SUBJECT: FSO Front and Mid-Exhaust Shields for Crosswind JS (Single Engine) and J T4F Sweepers Mounted on Certain Freightliner M2 Chassis

DATE: 1/15/2018

NUMBER: SB-0217-B

Operator Manual Daily/10hr Maintenance Requirements

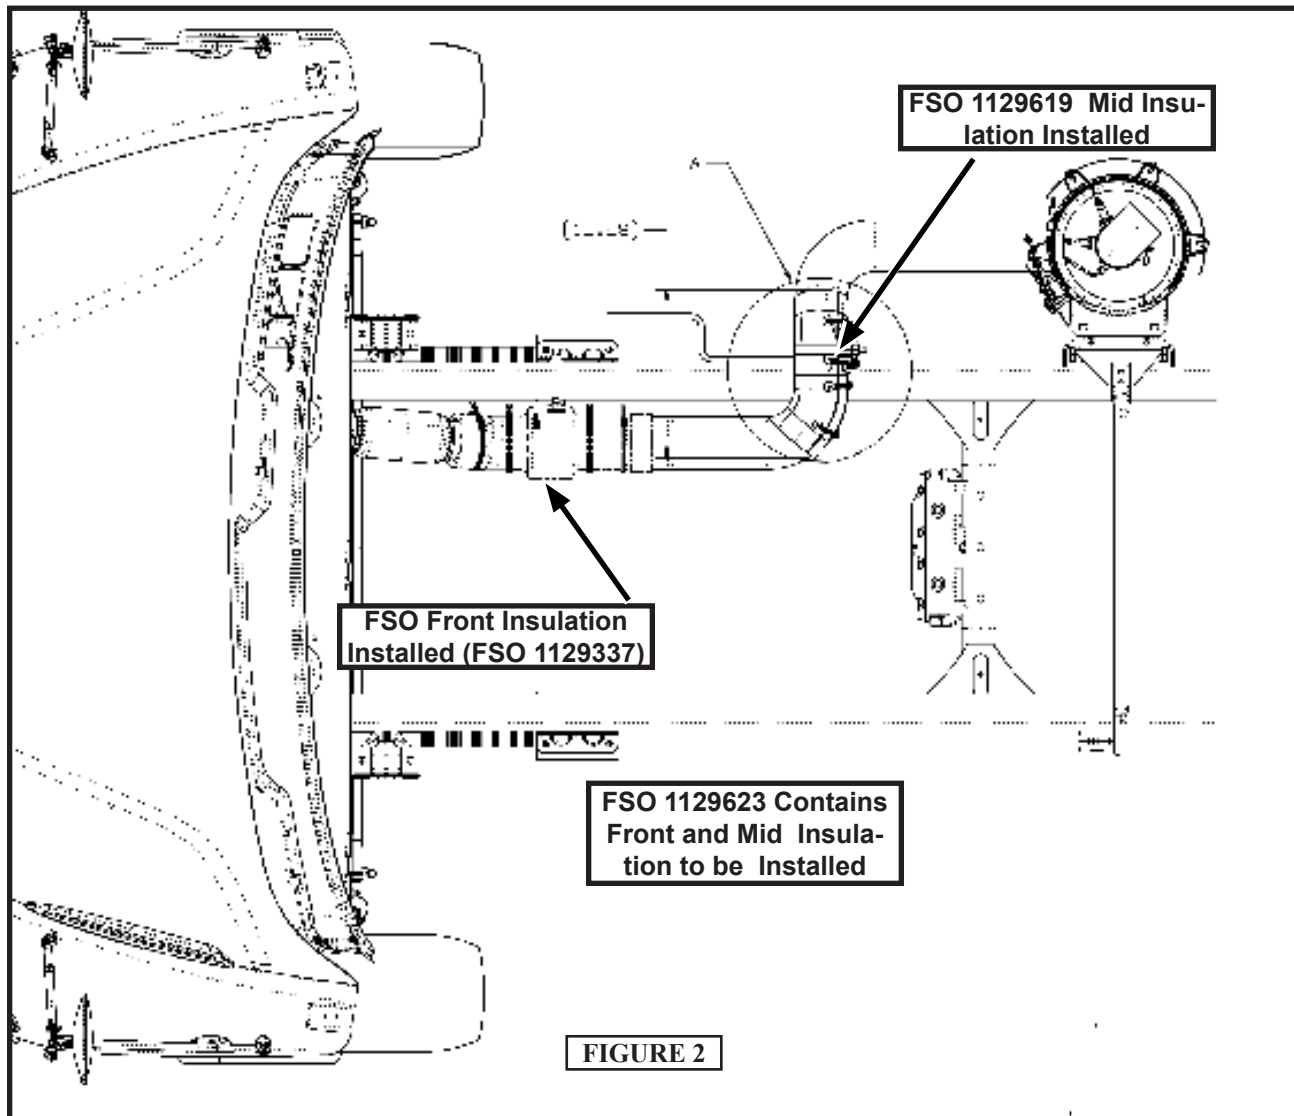
IMPORTANT: Leaves and light debris may be blown by the engine cooling fan to accumulate in the engine exhaust pipe area under the cab. During the required daily clean out of the sweeper, thoroughly remove leaves and debris that have accumulated near the exhaust pipe, and beneath the cab floor. (* Step #16, Daily Maintenance Requirements)

7. Check pickup head pressure slot. Clean and adjust, if necessary.
8. Check auxiliary engine oil level.
9. Check battery.
10. Check broom patterns.
11. Inspect spray water level.
12. Check centerboard for position.
13. Check vacuum enhancer.
14. Check hopper door seal.
15. Check impeller seal.
16. * Clean / wash down entire sweeper.
17. Check backup alarm for proper operation.
